Access Compliance Report

Public Rights-of-Way

(Curb Ramps)

Intersection ID: 10032791	Main Street: N_WENDOVER_RD	Cross Street: N/A	Location: NW
ADA ID: CBB8A7163FC0	Ramp Type: PerpDiag	Initial Pass/Fail: Fail	Overall Compliance: No
			Severity Score: 13.75

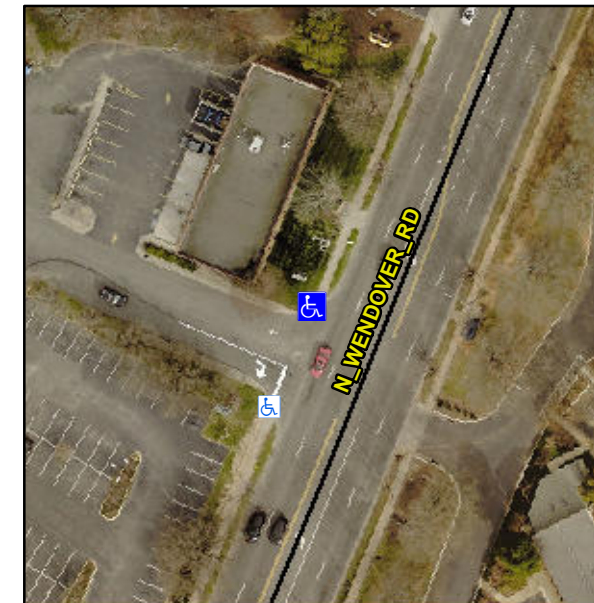
R304.2.2, R304.5.3

Compliance	Description	Data	Compliance	Description	Data
N/A	Ramp Length (in)	39.0	No	Ramp Slope (%)	8.6
Yes	Ramp Width (in)	48.0	No	Ramp XSlope (%)	2.8
N/A	Flare Type LT	N/A	N/A	Flare Type RT	N/A
N/A	Flare Slope LT (%)	N/A	N/A	Flare Slope RT (%)	N/A
N/A	Flare Traversable LT?	N/A	N/A	Flare Traversable RT?	N/A
N/A	Landing Length (in)	N/A	N/A	DWS Provided?	N/A
N/A	Landing Width (in)	N/A	N/A	DWS Contrast?	N/A
N/A	Landing Slope (%)	N/A	N/A	DWS Length (in)	N/A
N/A	Landing X Slope (%)	N/A	N/A	DWS Full Width?	N/A
N/A	Landing Curb? (Y/N)	N/A	N/A	DWS Offset (in)	N/A
N/A	Shared Landing?	N/A			
N/A	Gutter Ponding?	N/A	N/A	Gutter Slope (%)	N/A
N/A	Gutter Lip Ht (in)	N/A	N/A	Gutter X Slope (%)	N/A
N/A	Painted X Walk1?	No	N/A	Painted X Walk2?	No
	X Walk 1 Direction	To SW		X Walk 2 Direction	To SE
N/A	X Walk 1 Width (in)	N/A	N/A	X Walk 2 Width (in)	N/A
	X Walk 1 Slope (%)	0.5		X Walk 2 Slope (%)	1.4
	X Walk 1 X Slope (%)	0.1		X Walk 2 X Slope (%)	0.3

Remove & Replace Curb Ramp With Two New Directional Ramps or Equivalent.
